UPGRADING FROM THE Si7005 TO THE Si7015

This application note covers some detailed considerations for migrating from the Si7005 to the Si7015.

Figure 2. Typical Si7015 Application Circuit for Battery-Powered Applications

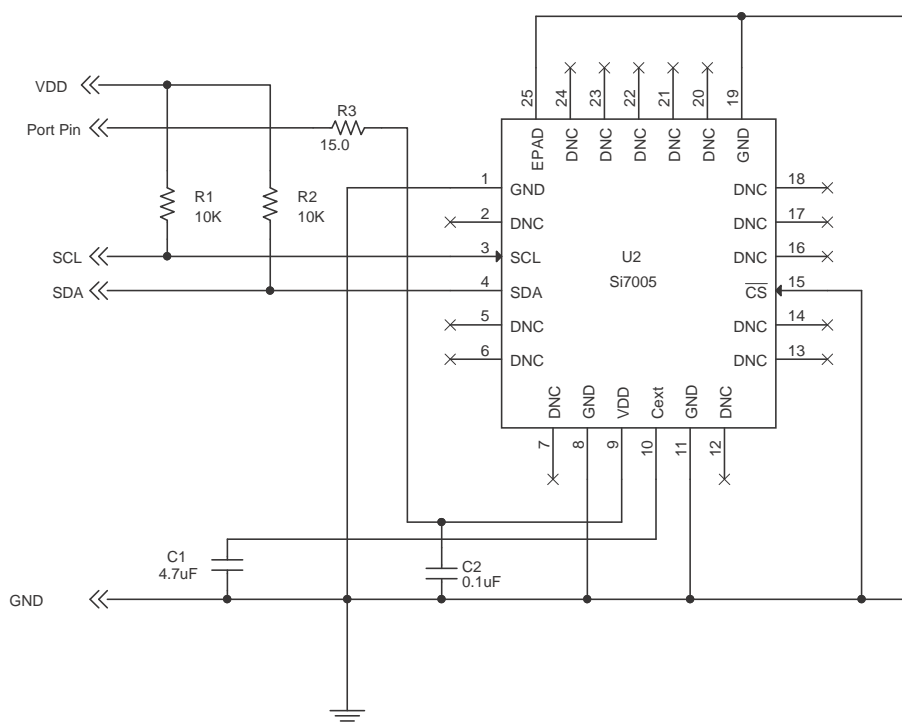
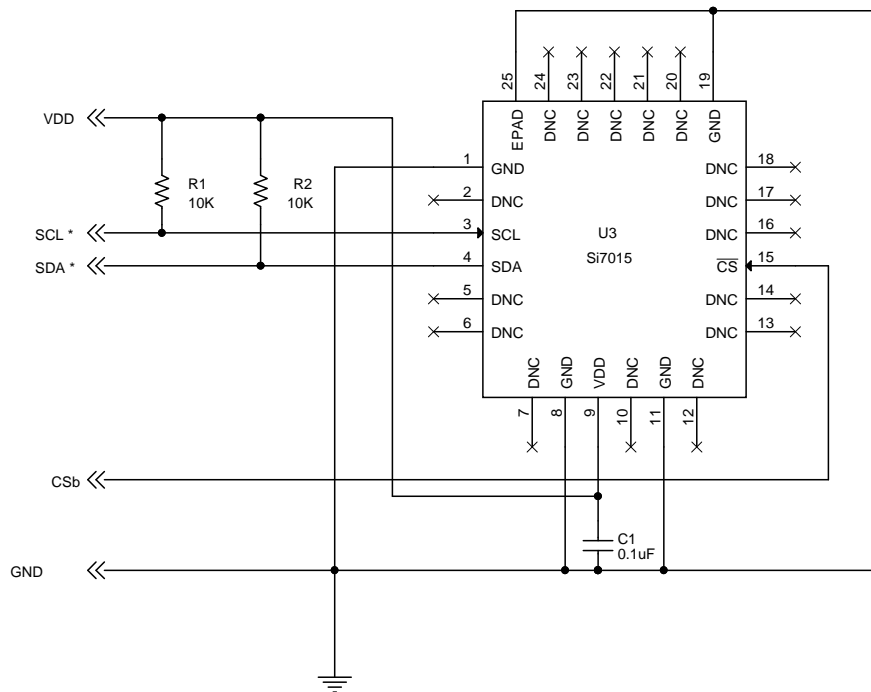
- The package dimensions and pin-out are identical; no changes are required to the PCB layout for the 4x4 QFN package.
- The bypass capacitor that supports the Si7005's on-chip linear regulator, C1 in Figure 1, is no longer required, but it can be left in place if desired.
- The SDA and SCL pins of the Si7015 may not be driven to voltages above V_{DD}. Switching V_{DD} low was possible with the Si7005, as shown in Figure 1. With the Si7015, switching V_{DD} low with SDA SCL high is not possible, so it should be connected as shown in Figure 2. Because the Si7015's standby power consumption is exceptionally low, it is not necessary to switch V_{DD} off to save power.

In Figure 2, Pin 10 is internally connected but can have a capacitor to ground. \overline{CS} can be tied to ground, and I^2C commands can be used to put the part in low-power mode.

- The strength of the output drivers on the Si7015's SDA and SCL output pins differs from that of the Si7005:
Si7005: IOL = 8.5 mA @ VOL = 0.6 V
Si7015: IOL = 2.5 mA @ VOL = 0.6 V
- There is no internal pull-down resistor on the Si7015's chip select pin (\overline{CS}) as with the Si7005. The Si7015's \overline{CS} pin should not be left floating/unconnected. It should be tied to GND if it is not used.
- As is the case with the Si7005, pins 2, 5–7, 12–14, 16–18, and 20–24 should be floating, i.e., not connected to any electrical signals, power, or ground. If any of these pins have any electrical connection in your system, please contact a Silicon Labs FAE for assistance.
